ADDENDUM NO. CC-1

Papillion La Vista Community Schools  
Trumble Park Elementary - Reroof 2026  
500 Valley Road, Papillion, NE 68046  
BCDM Project No. 3412-04

NOTICE TO BIDDERS: The Project Manual and Drawings for the above referenced project are hereby amended as follows:

**1 DEMOLITION PLAN - ROOF PLAN**  
1/16" = 1'-0" 0' 1' 16" 32'

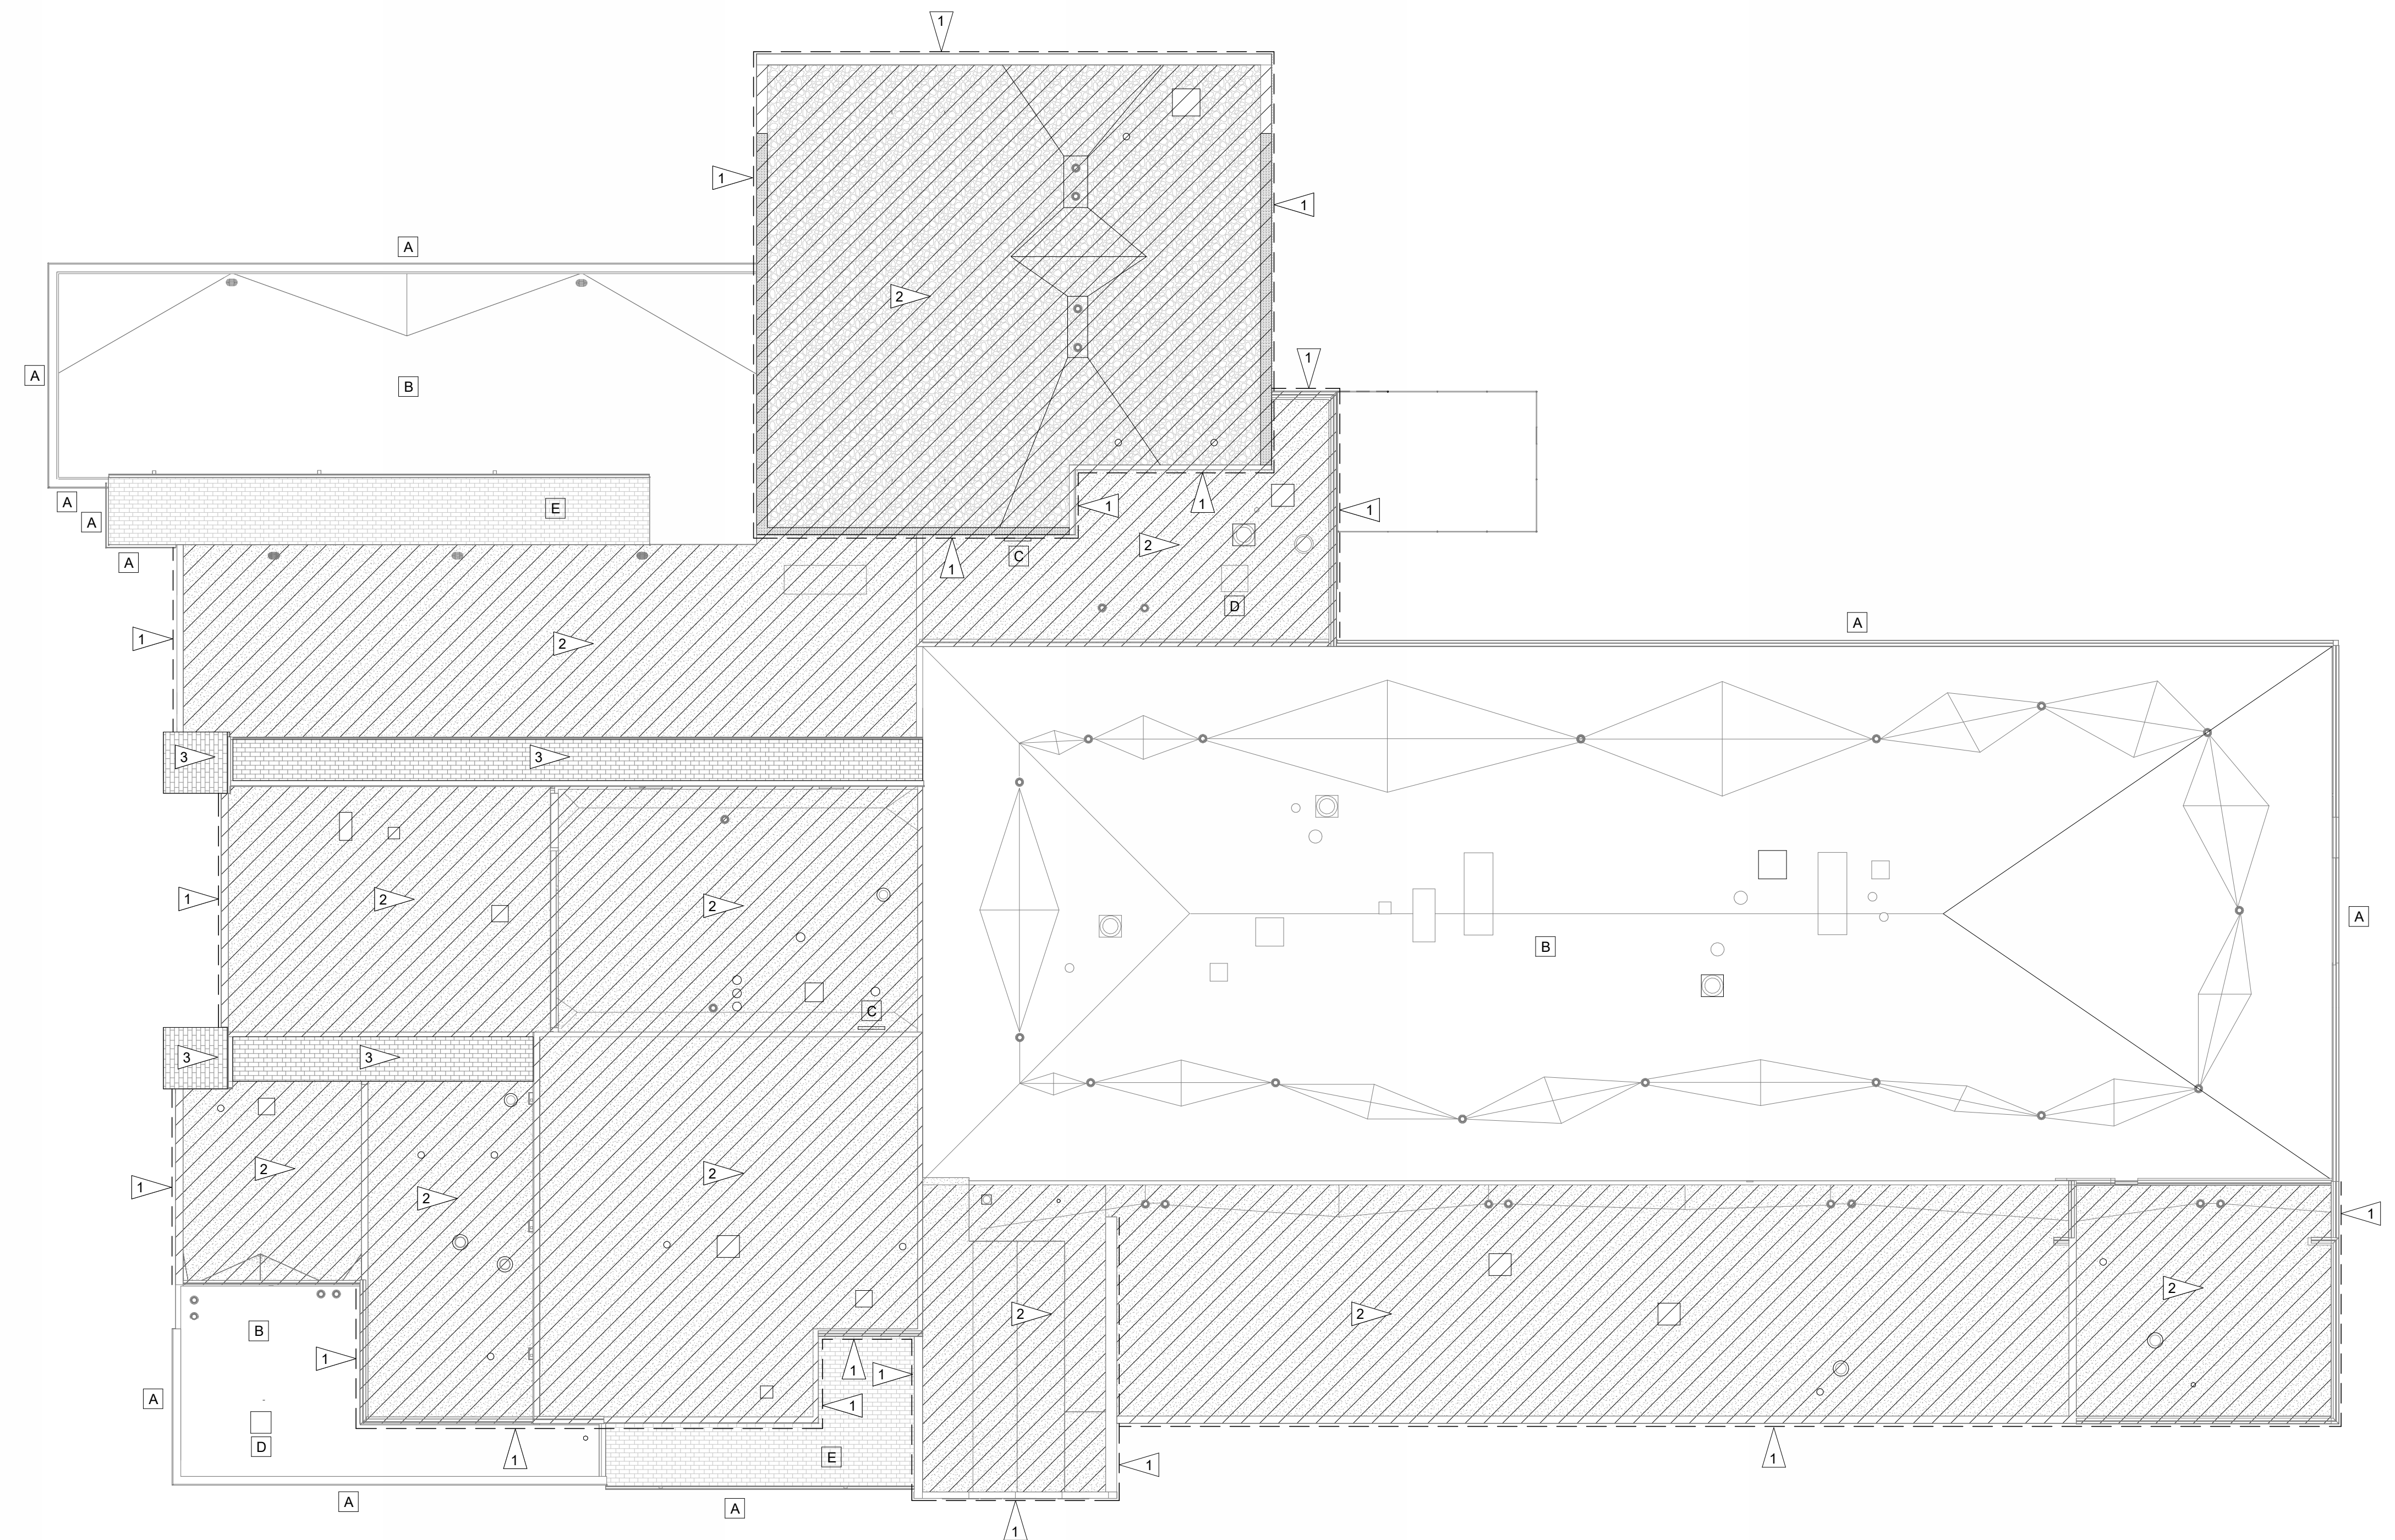
- a. At ROOF PLAN LEGEND, change the ballasted roof text to read: "PER BASE BID, SALVAGE ROCK BALLAST AND PREP EXISTING EPDM FOR NEW 60 MIL EPDM ROOFING. EXISTING ROCK BALLAST TO BE REINSTALLED."

- b. At ROOF PLAN LEGEND, change the new asphalt roof shingles text to read: "REMOVE EXISTING ROOF SHINGLES DOWN TO EXISTING SUBSTRATE. REMOVE EXISTING FLASHING AND WOOD BLOCKING AS NEEDED. PROVIDE NEW ROOF SHINGLES, ICE AND WATER SHIELD, AND PREFABRICATED METAL ROOF FASCIA."

- c. At ROOF PLAN LEGEND, change the existing epdm roof text to read: "PER BASE BID, REMOVE ROOF EDGE METAL FLASHING. EXISTING EPDM MEMBRANE AND INSULATION TO REMAIN. PROVIDE NEW ADHERED EPDM MEMBRANE OVER EXISTING MEMBRANE AND PROVIDE NEW PREFABRICATED METAL ROOF FASCIA."

- d. At DEMOLITION FLAG NOTES: add flags notes 2 and 3:
  - a. Flag Note 2: UNDER BASE BID, PREP FOR NEW ADHERED ROOFING. SEE ROOF LEGEND FOR EXTENTS.
  - b. Flag Note 3: UNDER BASE BID, REMOVE EXISTIN SHINGLES AND PREP FOR NEW ASPHALT SHINGLES. SEE ROOF LEGEND FOR EXTENTS.

14 ROOF DETAIL AT CLERESTORY WINDOW  
A1-2 1 1/2" = 1'-0" | 0' | 8" | 1'-4"

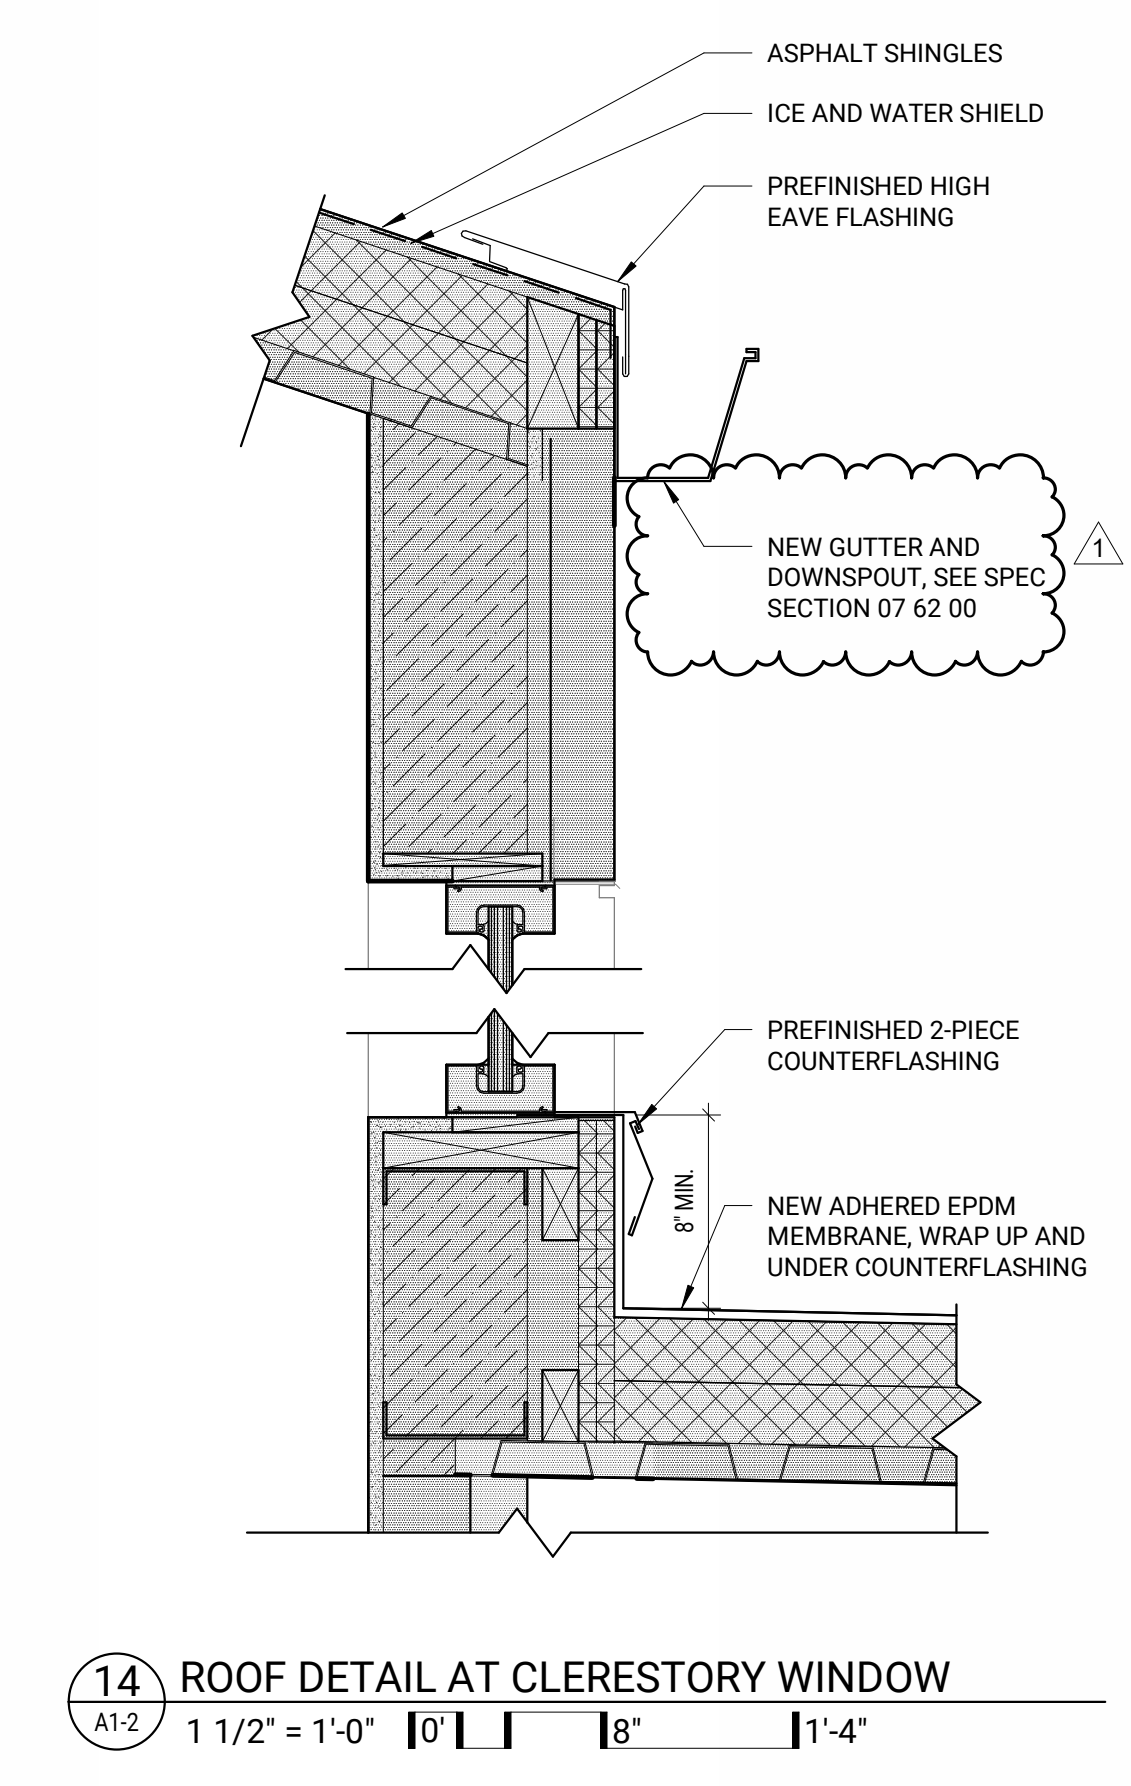
- c. At ROOF PLAN LEGEND, change the new epdm roof text to read: “PER BASE BID, REMOVE ROOF EDGE METAL FLASHING. EXISTING EPDM MEMBRANE AND INSULATION TO REMAIN. PROVIDE NEW ADHERED EPDM MEMBRANE OVER EXISTING MEMBRANE AND PROVIDE NEW PREFABRICATED METAL ROOF FASCIA.”
- d. At view 8, add a note to remove and replace existing siding as required to install flashing.
- e. At view 14, add a note for the new gutter and downspout.

1 ROOF PLAN  
A1-2 1/16" = 1'-0" | 0' | 16" | 32"

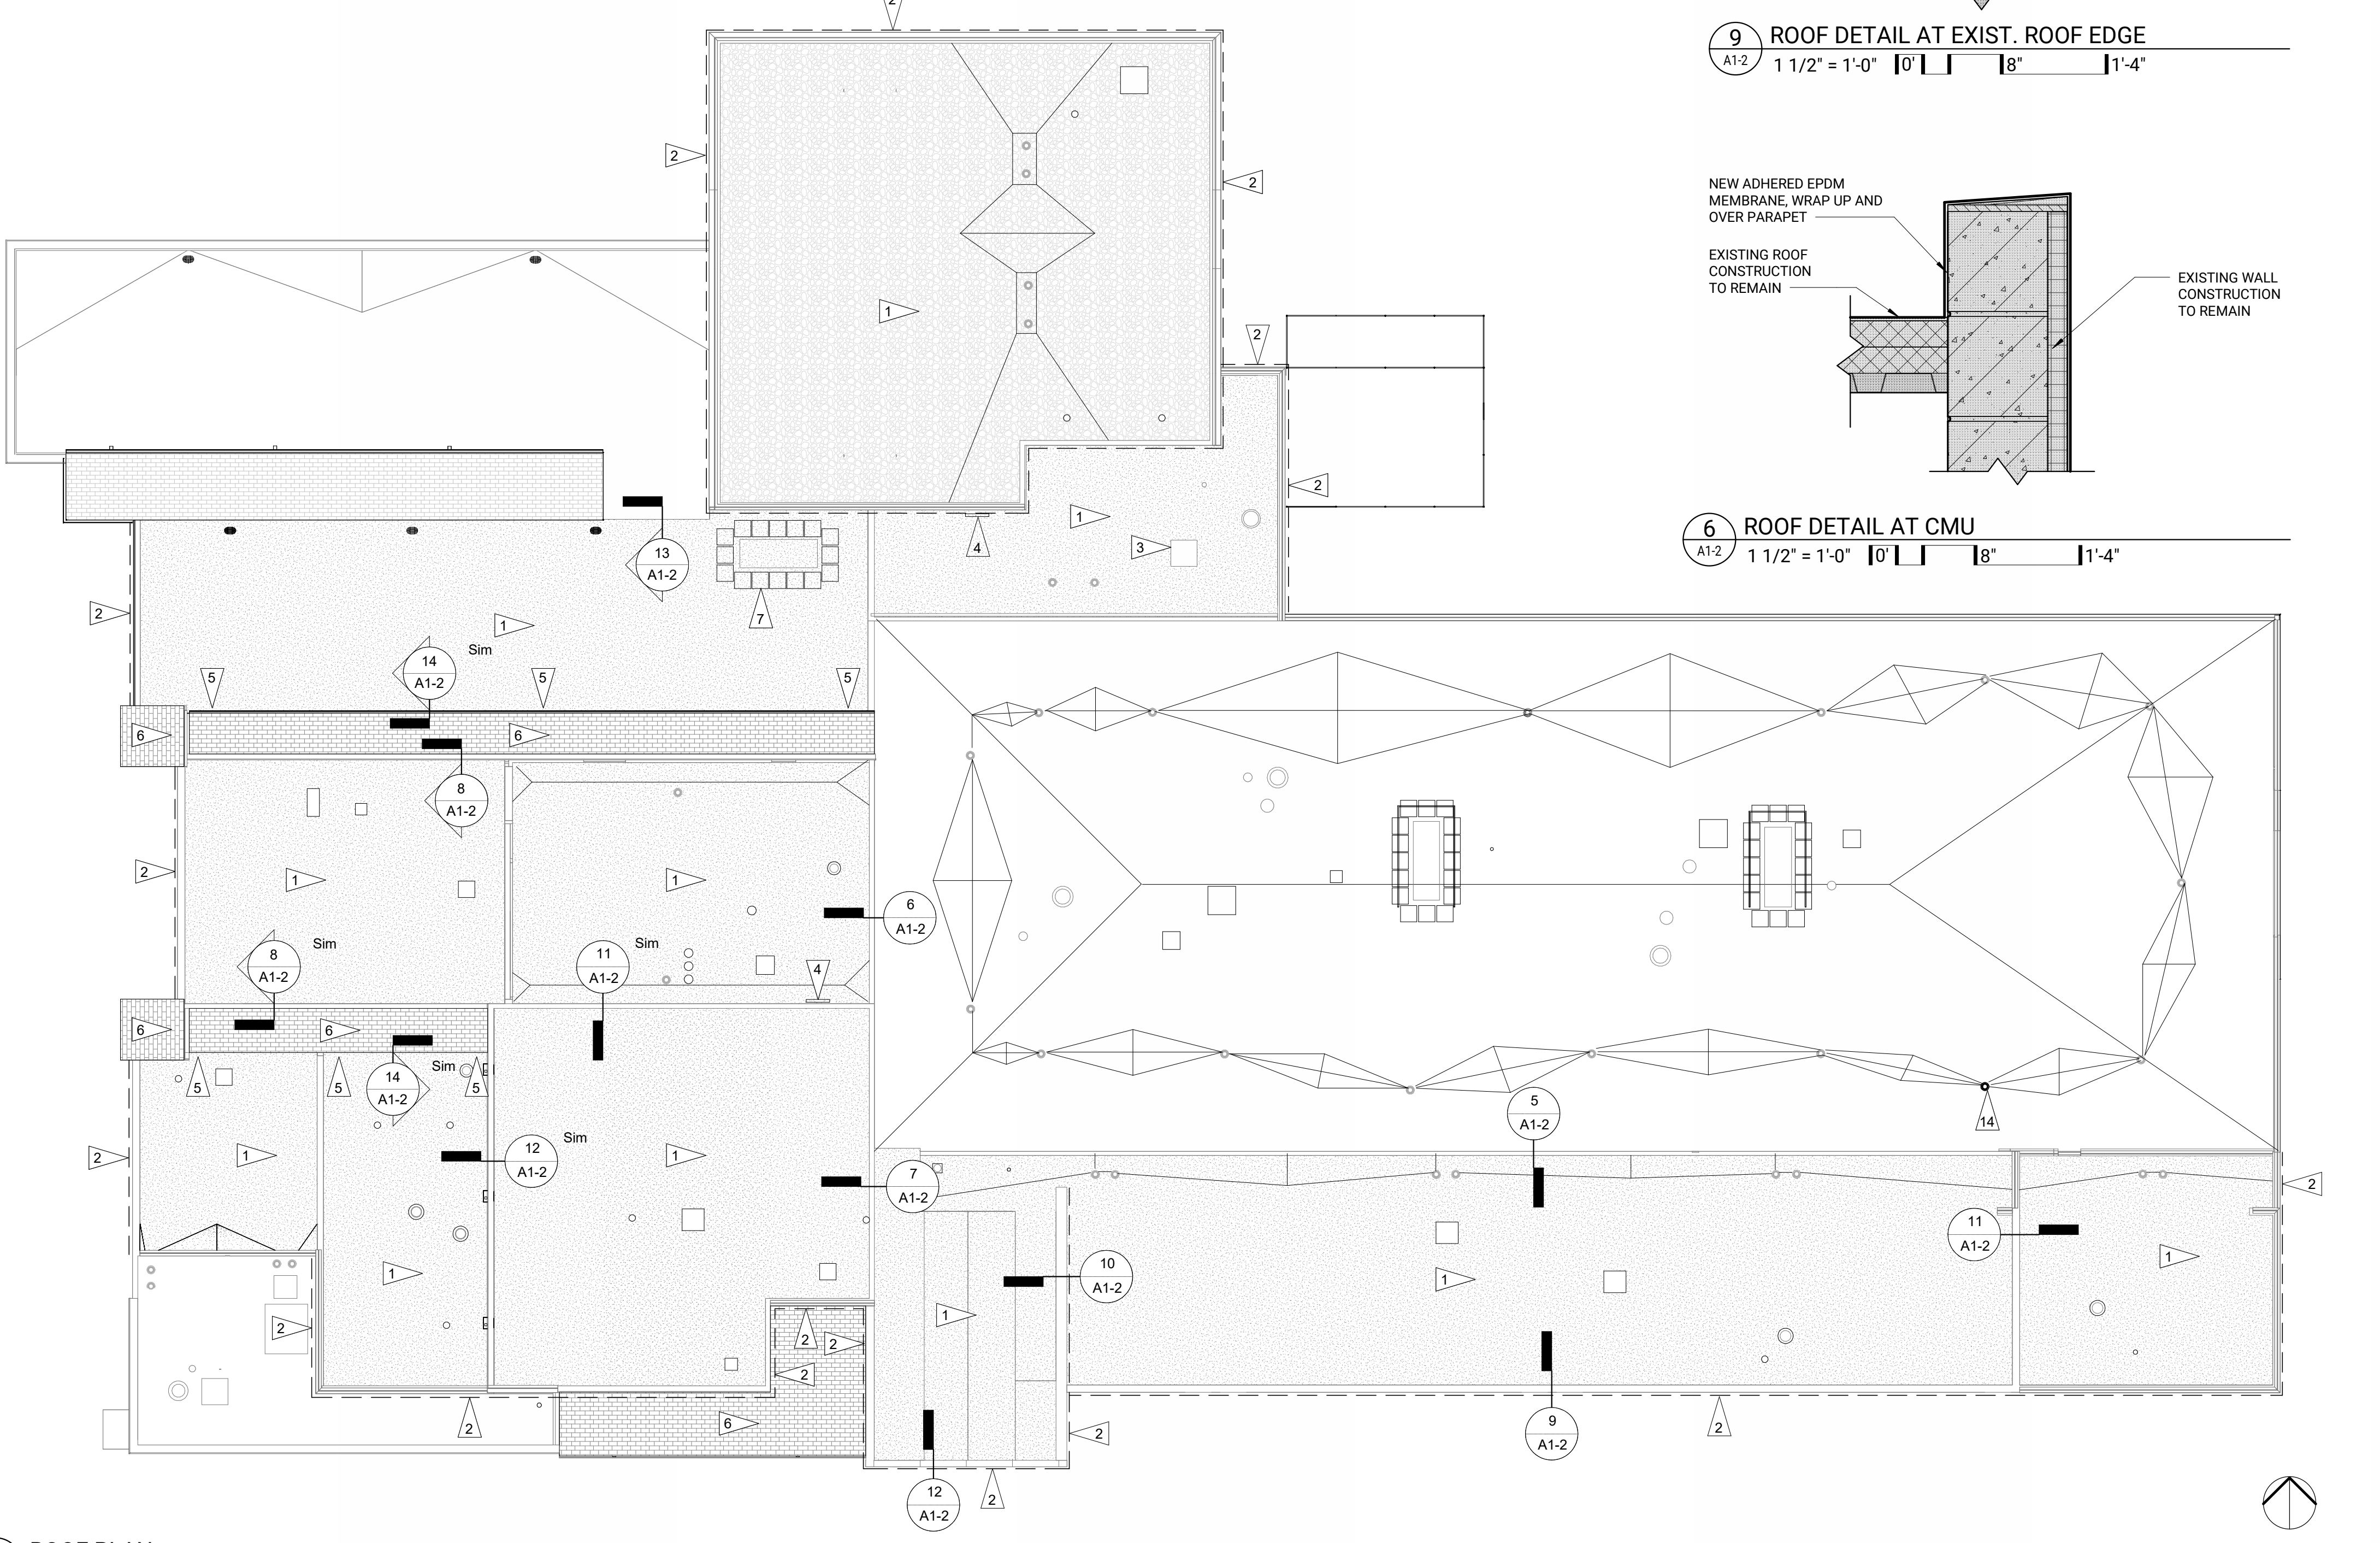
- a. At ROOF PLAN LEGEND, change the ballasted roof text to read: "PER BASE BID, SALVAGE ROCK BALLAST AND PREP EXISTING EPDM FOR NEW 60 MIL EPDM ROOFING. EXISTING ROCK BALLAST TO BE REINSTALLED."
- b. At ROOF PLAN LEGEND, change the new asphalt roof shingles text to read: "REMOVE EXISTING ROOF SHINGLES DOWN TO EXISTING SUBSTRATE. REMOVE EXISTING FLASHING AND WOOD

BLOCKING AS NEEDED. PROVIDE NEW ROOF SHINGLES, ICE AND WATER SHIELD, AND PREFABRICATED METAL ROOF FASCIA.”
